PRELIMINARY SHORT PLAT (SP) AND PLANNED RESIDENTIAL DEVELOPMENT (PRD) APPROVAL

PROJECT INFORMATION									
Project Title	Clancy Short Plat Planned Residential Development			Date of Report	May 18, 2021				
File Number	SP20-006			Attachments	Preliminary Short Plat PRD Map (Exhibit 17)				
Administrative Recommendation	Approve the Preliminary Short Plat (SP) and Planned Residential Development (PRD) request to allow the construction of a 7-lot residential PRD, subject to the conditions of approval contained in Section 2.0.								
BACKGROUND SUMMARY									
Owner/Applicant	James Clancy								
Request	Preliminary Short Plat and Planned Residential Development approval in order to subdivide a 1.62-acre property into seven (7) single-family lots.								
SEPA Status	This project is categorically exempt from SEPA review pursuant to MMC 22E.030.090.								
Location	4600 Block of 61 st Drive NE			APN(s)	30053400404700				
Legal Description (abbreviated)	Parcel A, City of Marysville BLA, File No. 20-001, AFN 202007215006			Section	34	Township	30	Range	05

SP20-006 Clancy Preliminary Short Plat and Planned Residential Development Approval

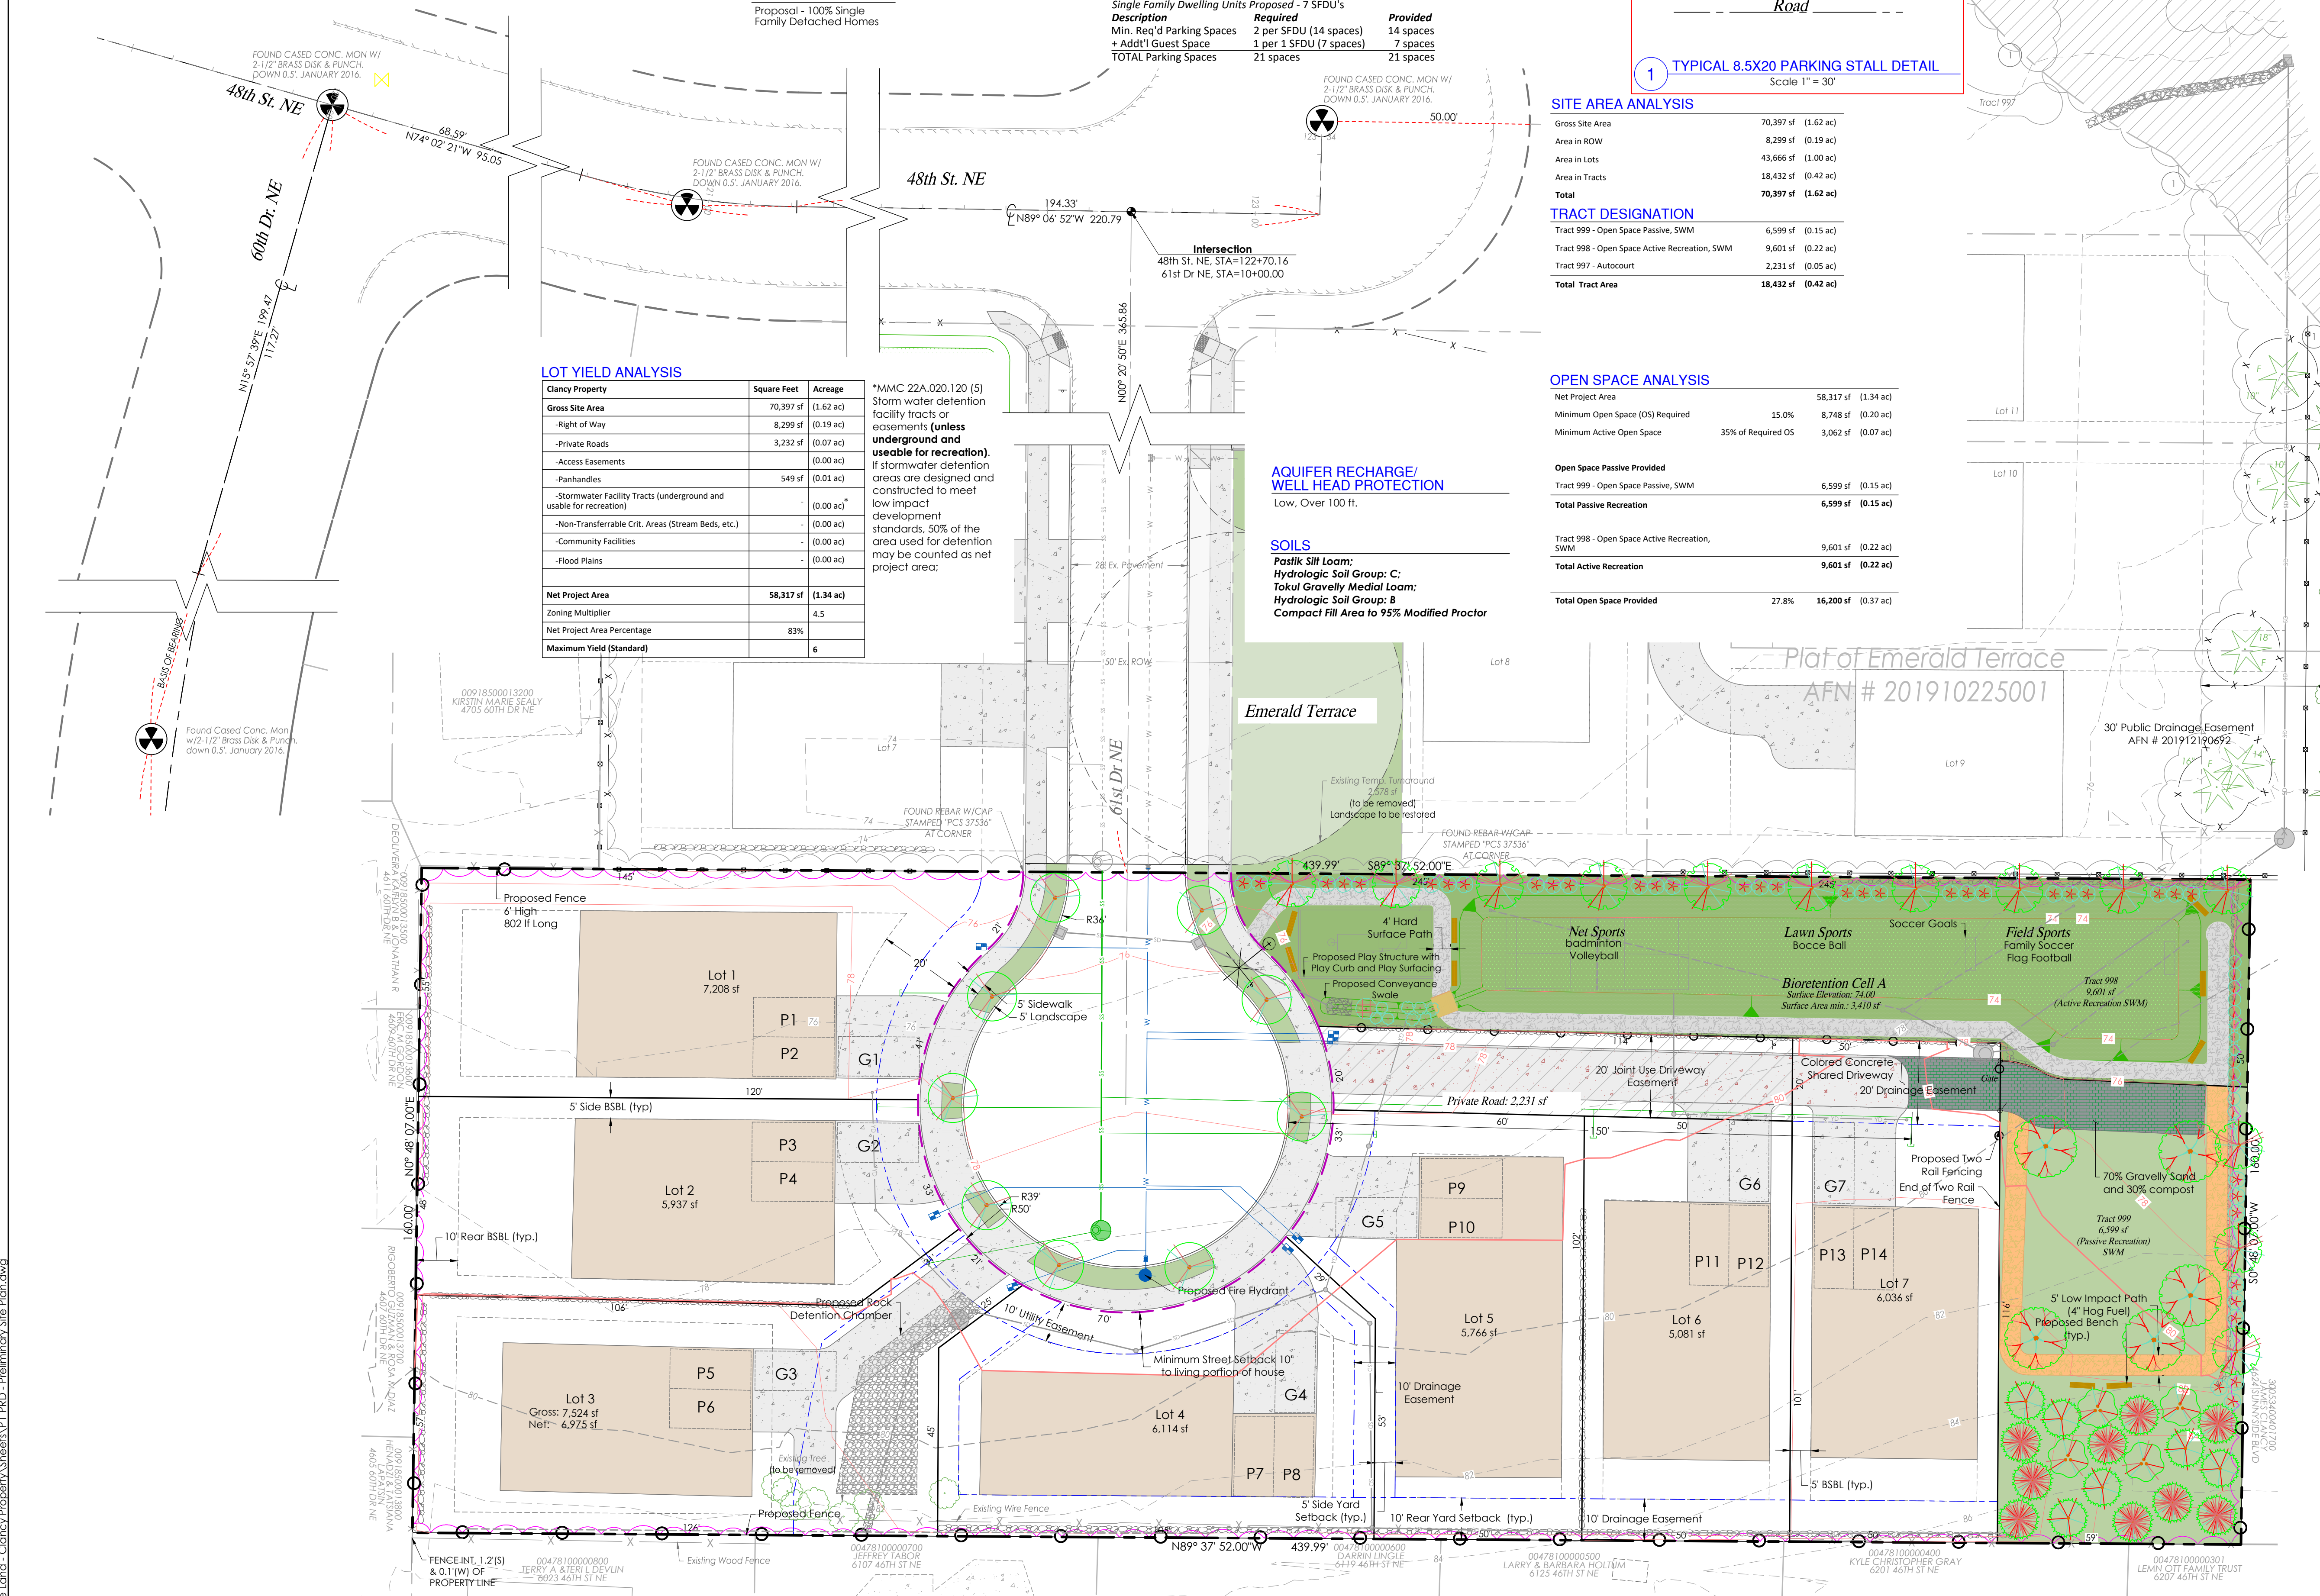
- c. The joint use private drive serving lots 6 and 7 shall be constructed with scored concrete, paving blocks, bricks, or other ornamental pavers to clearly indicate that the entire surface is intended for pedestrians as well as vehicles. A detail of the surfacing of the joint use private drive will be required to be provided on the civil construction plans and approved by the City Engineer.

- a. *Marysville Fire District:* The proposed fire hydrant location at the end of the cul-de-sac is acceptable. The following relate to fire code compliance for this project:
 - The project shall comply with the current fire code requirements (2015 IFC) including WA State and local City of Marysville amendments to the fire code.

- Existing fire hydrant spacing along the roadway appears adequate. The city GIS water map shows the two closest hydrants along the roadway frontages are spaced less than 600' apart.

- Access planned appears adequate for fire apparatus. Access of 28' wide is shown on the plan.
- Turnaround provision is required for dead-end access in excess of 150 feet long.

1. The attached Preliminary Short Plat and Planned Residential Development map submitted on April 2, 2021 (Exhibit 17) will be the approved lot configuration.
2. Prior to civil construction plan approval, a final landscape plan shall be submitted consistent with MMC 22C.120, *Landscaping and Screening*. All required landscaping, fencing, and open space improvements shall be installed prior to final Short Plat/PRD approval.
3. Prior to civil construction plan approval, the civil construction and landscape plans will be required to be amended to incorporate an accessible path or ramp(s) for access into dual use bioretention/active recreation facility Tract 998 to account for the two-foot grade change from the surrounding land. The path or ramp(s) shall be paved and meet accessibility requirements.

6. The applicant shall be required to construct the 61st Drive NE frontage improvement extension, including removal of the temporary cul-de-sac within the plat of Emerald Terrace, prior to final short plat/PRD approval. Roadway improvements, channelization, site access and lighting plans will be required to be reviewed and approved by the City Engineer, prior to construction plan approval.

7. The joint use private drive serving lots 6 and 7 shall be constructed with scored concrete, paving blocks, bricks, or other ornamental pavers to clearly indicate that the entire surface is intended for pedestrians as well as vehicles. A detail of the surfacing of the joint use private drive will be required to be provided on the civil construction plans and approved by the City Engineer.
